Whitfield-Manjiro House

Town of Fairhaven ADA Transition Plan

July 2024

Institute for Human Centered Design

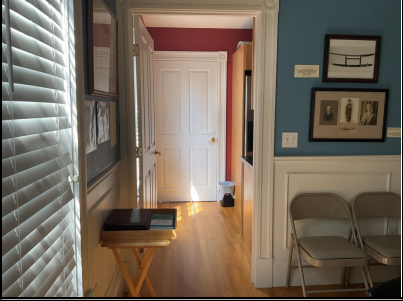
- Recommend providing visual contrast on all stair treads.
- Recommend providing a print out with photos and descriptions of the exhibit.

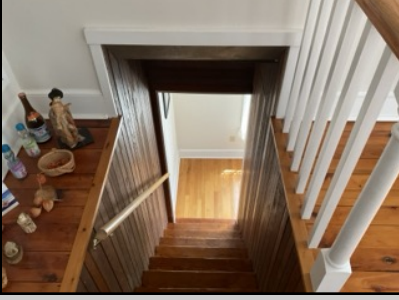
5	East Side Entrance, Bottom Landing	Ext.		Exterior Ramp	N/A		Ramp < 48" wide Landing has a slope > 1:50 in either direction No top or bottom landing provided	41.5" 3.6% -	Rebuild the ramp to be 48" wide min. Alter so that the slope in all directions is no greater than 1:50 (2.00%) Provide landing at the top and bottom of ramp.	1	-	-

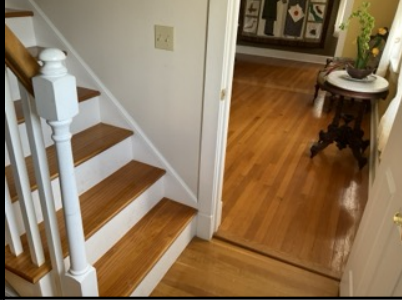
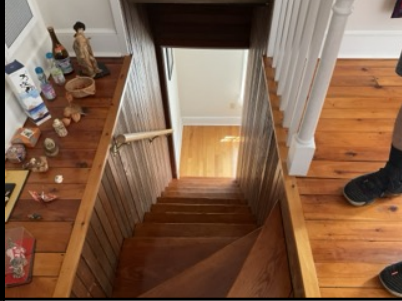
ID	Location	Floor	Room	Element	Type	Photo	Issues	Current Measure	Recommendations	Quantity	Price	Cost Estimation
6	East Side Entrance, Top Landing	Ext.		Exterior Ramp	N/A		Handrails do not extend 12" past top & bottom	-	Alter handrails to extend horizontally above the landing for 12" min. beyond the top and bottom of ramp runs.	1	-	-
7	East Side Entrance, Top Landing	Ext.		Exterior Ramp	N/A		Landing < 60" min. long	42.75"	Rebuild the ramp to provide a 60" min. deep landing.	1	-	-
8	East Side Entrance, Middle Landing	Ext.		Exterior Ramp	N/A		Landing not as wide as ramp	35"	Rebuild the ramp to ensure that the landing is as wide as the ramp.	1	-	-
Exterior Stair												
9	West Side Entrance	Ext.		Exterior Stair	N/A		Bottom handrail extends < 12" + one tread Cross section of handrail is not compliant Handrail not provided on both sides	<ul style="list-style-type: none">---	Bottom: Ensure that the sloped bottom extension extends one tread depth min. beyond last riser nosing in same direction as stair flight. Provide handrails with 1 1/4" - 2" circular cross sections. Provide a handrail on each side.	1	<ul style="list-style-type: none">---	<ul style="list-style-type: none">---

Entrance												
10	West Side Entrance	Ext.		Entrance	Main Entrance		Directional sign to accessible entrance not provided	-	Provide a directional sign indicating the location of the nearest accessible entrance.	1	450	\$450
											450
